REDTAIL RANCH FILING NO. 1

A REPLAT OF LOTS 1 AND 2, WALKER PLACE, TOGETHER WITH A PORTION OF SECTION 9, TOWNSHIP 12 SOUTH, RANGE 65 WEST OF THE SIXTH PRINCIPAL MERIDIAN, EL PASO COUNTY, COLORADO

REDTAIL RANCH FILING NO. 1
2525.00
MARCH 13, 2018
REV. NOVEMBER 15, 2018
SHEET 2 OF 3

REDTAIL RANCH FILING NO. 1
2525.00
MARCH 13, 2018
REV. NOVEMBER 15, 2018
SHEET 3 OF 3

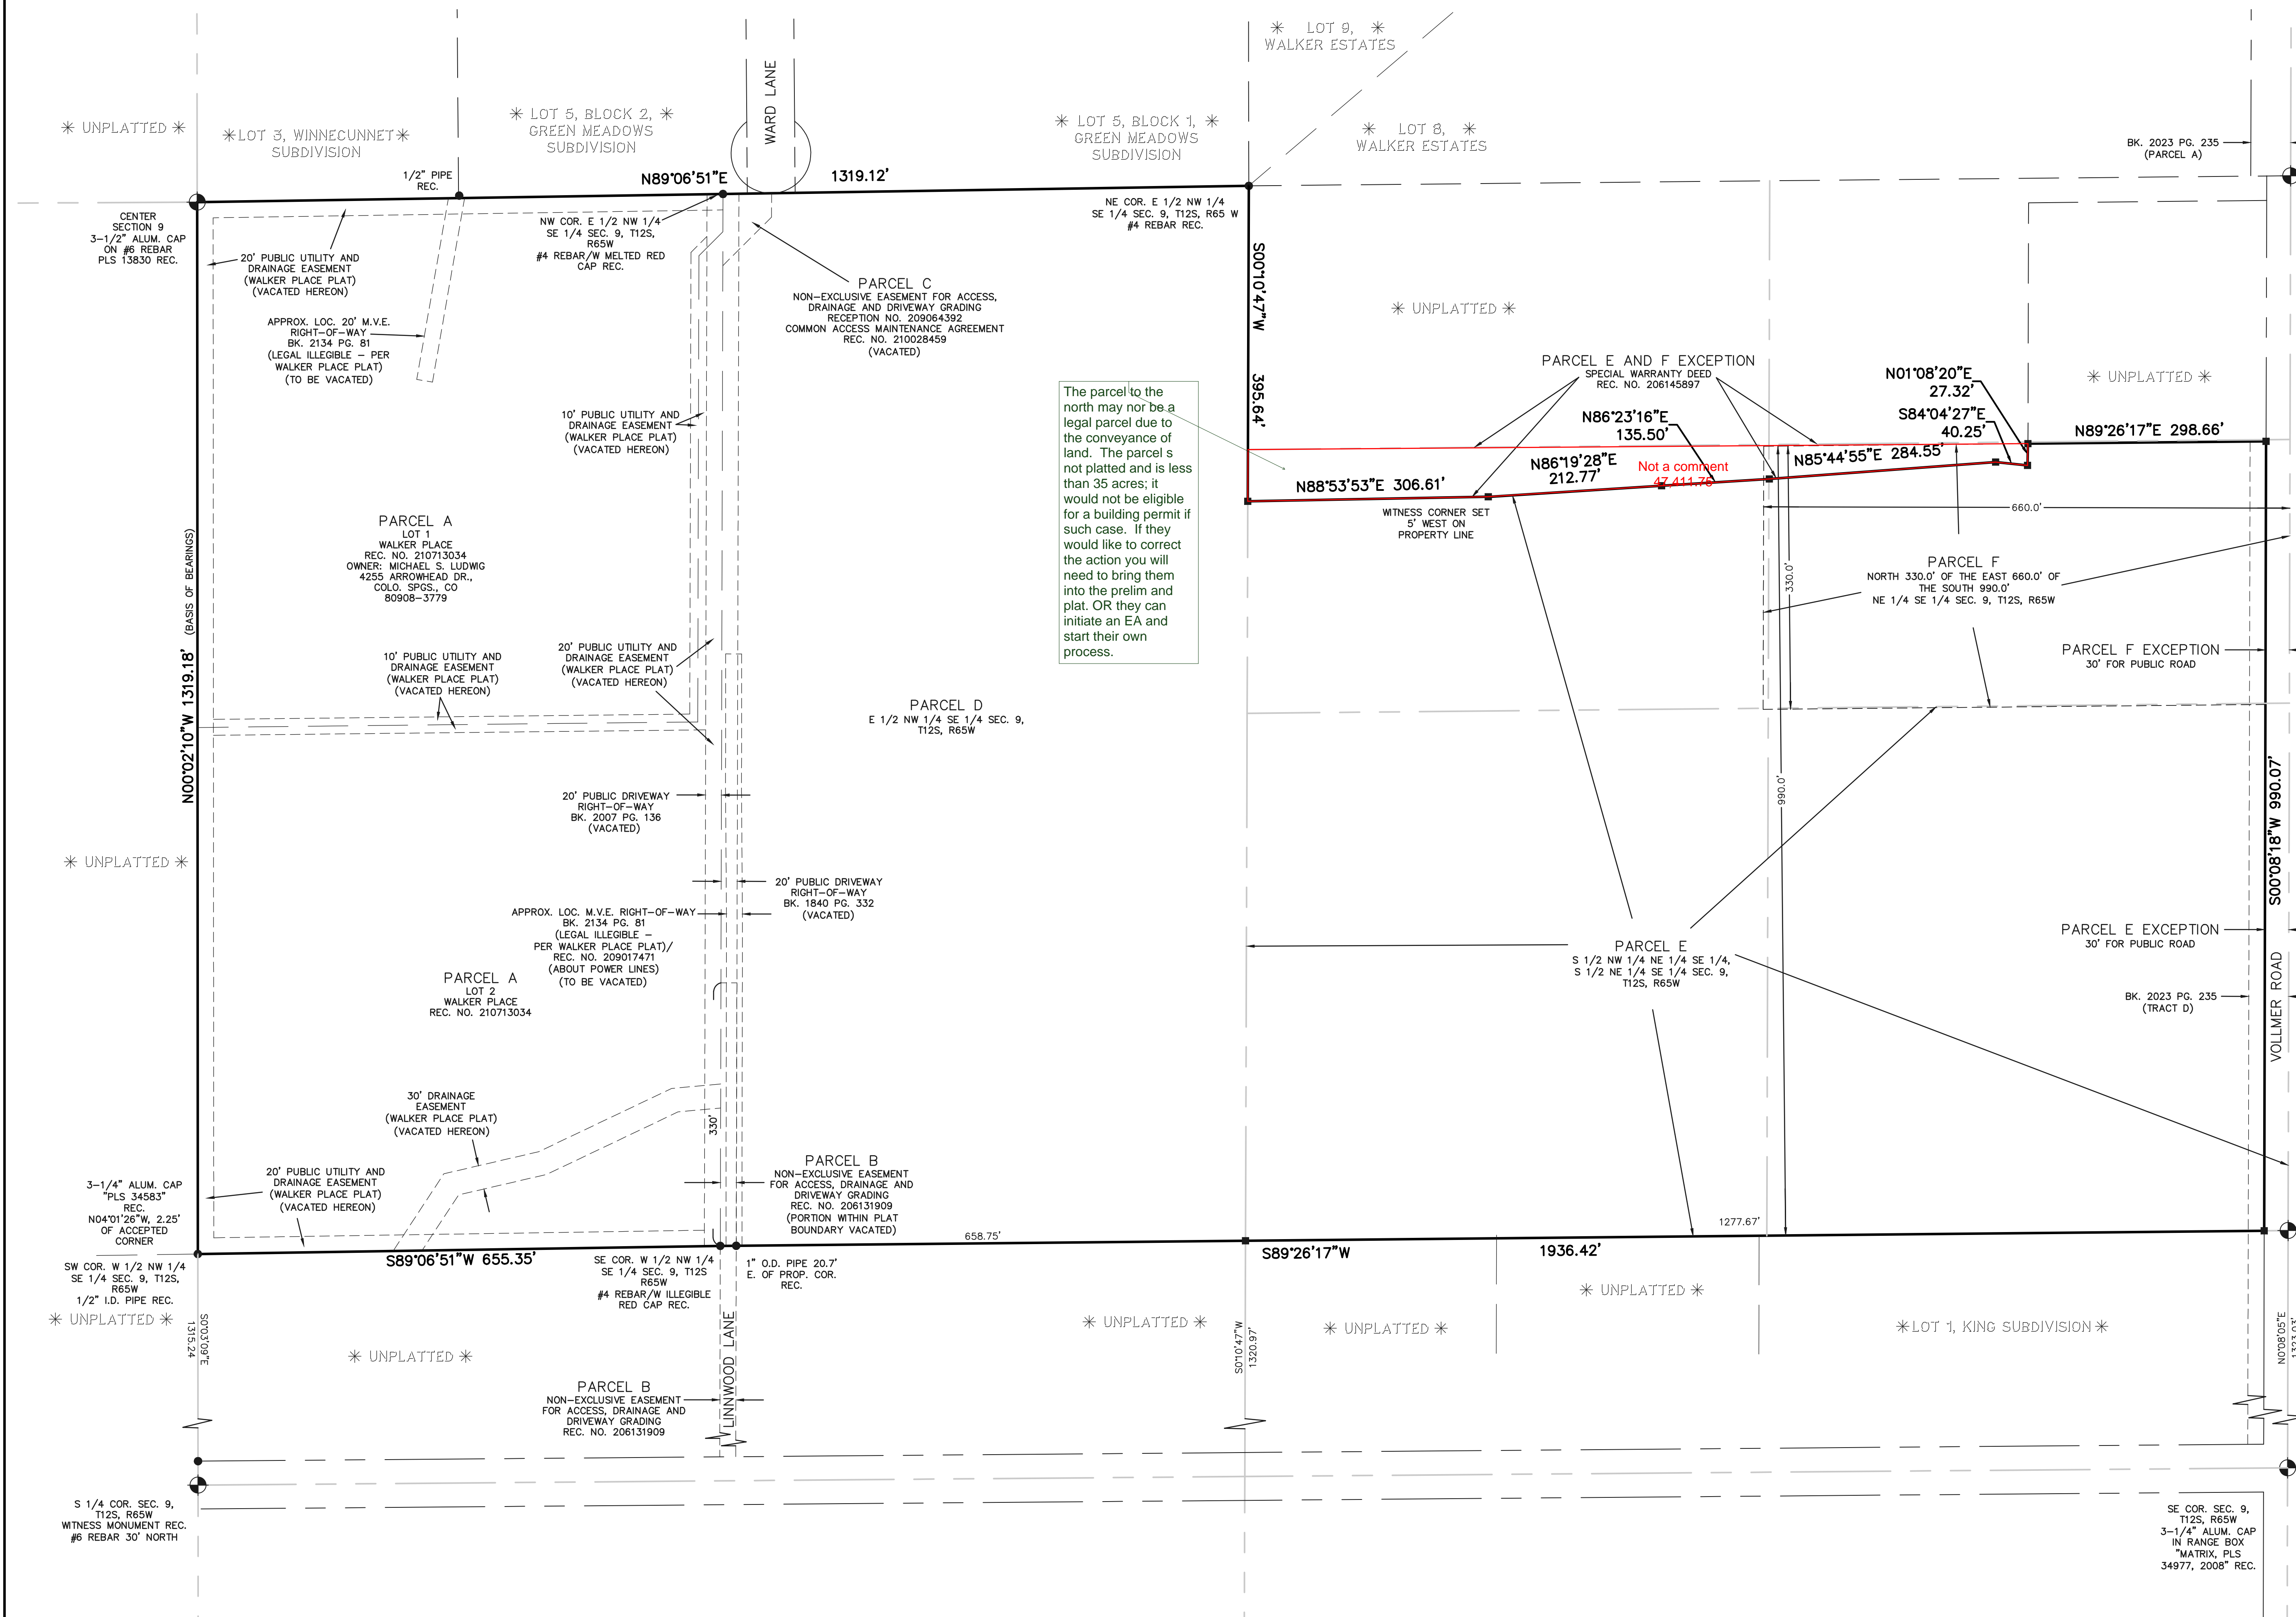
The parcel to the north may not be a legal parcel due to the conveyance of land. The parcel is not platted and is less than 35 acres; it would not be eligible for a building permit if such case. If they would like to correct the action you will need to bring them into the prelim and plat. OR they can initiate an EA and start their own process.

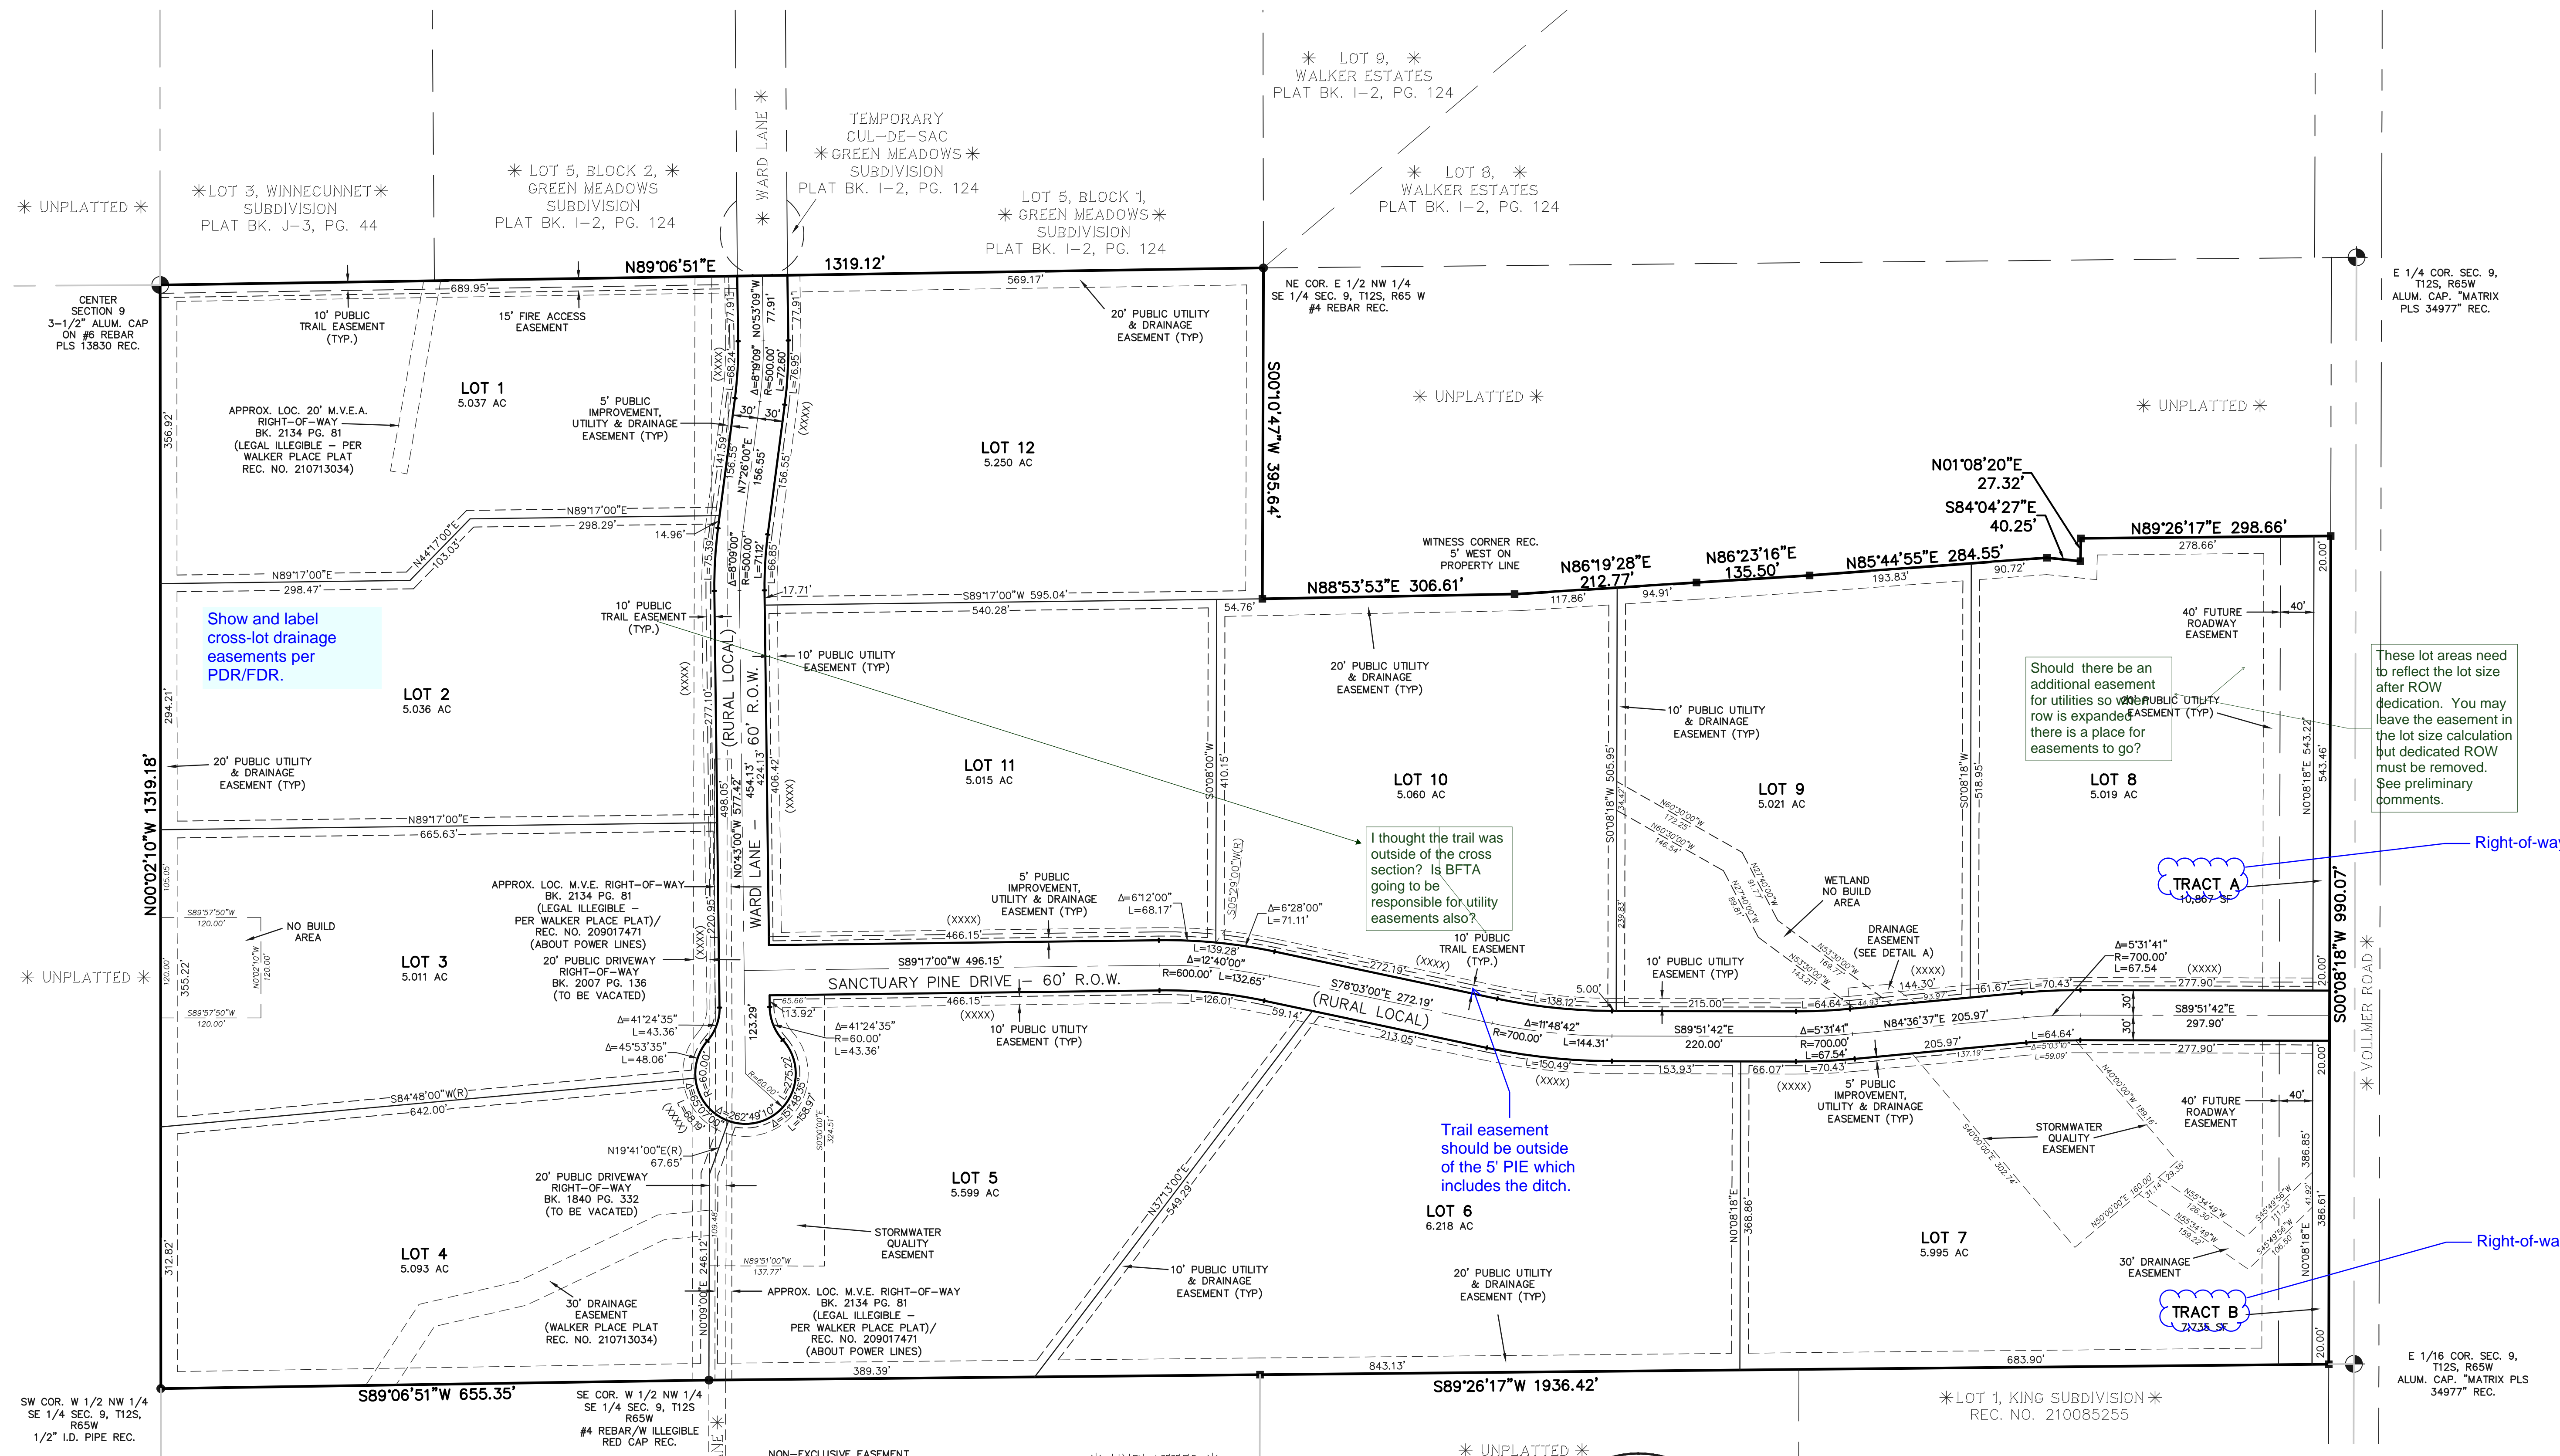
Show and label cross-lot drainage easements per PDR/FDR.

I thought the trail was outside of the cross section? Is BFTA going to be responsible for utility easements also?

Trail easement should be outside of the 5' PIE which includes the ditch.

Should there be an additional easement for utilities so when the public utility row is expanded there is a place for easements to go?

These lot areas need to reflect the lot size after ROW dedication. You may leave the easement in the lot size calculation but dedicated ROW must be removed. See preliminary comments.

Right-of-way

Right-of-way
